APPLICATION NO.	FILING DATE	FIRST NAMED INVENTOR	ATTORNEY DOCKET NO.	CONFIRMATION NO.
10/585,227	11/06/2006	Soheyl Mottahedeh	CU-4925 BWH	9363
26530 09012909 LADAS & PARRY LLP 224 SOUTH MICHIGAN AVENUE			EXAMINER	
			SCRUGGS, ROBERT J	
SUITE 1600 CHICAGO, IL 60604			ART UNIT	PAPER NUMBER
			3723	
			MAIL DATE	DELIVERY MODE
			09/01/2009	PAPER

Application No. Applicant(s) 10/585,227 MOTTAHEDEH, SOHEYL Office Action Summary Examiner Art Unit ROBERT SCRUGGS -- The MAILING DATE of this communication appears on the cover sheet with the correspondence address --Period for Reply A SHORTENED STATUTORY PERIOD FOR REPLY IS SET TO EXPIRE 3 MONTH(S) OR THIRTY (30) DAYS. WHICHEVER IS LONGER, FROM THE MAILING DATE OF THIS COMMUNICATION. Extensions of time may be available under the provisions of 37 CFR 1.136(a). In no event, however, may a reply be timely filed after SIX (6) MONTHS from the mailing date of this communication. If NO period for reply is specified above, the maximum statutory period will apply and will expire SIX (6) MONTHS from the mailing date of this communication - Failure to reply within the set or extended period for reply will, by statute, cause the application to become AB

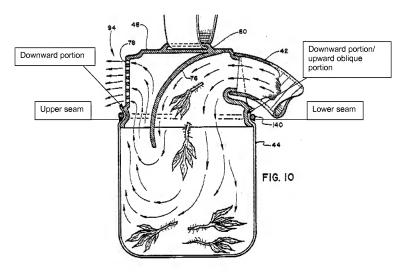
In reference to claim 10. Cleworth also shows that said inlet is defined between two

adjacent seams formed as the two inner seams of bag (44) (Figure 10).

In reference to claim 11, Cleworth also shows that said two adjacent seams comprise upper and lower seams, said lower seam comprising a downward portion providing for said opening to comprise a downward arrangement (see figure below).

In reference to claim 12, Cleworth also shows that said two adjacent seams comprise upper and lower seams, said lower seam comprising an upward oblique portion

providing for said opening to comprise an upwardly slanted arrangement (see figure

ab**o**ve).
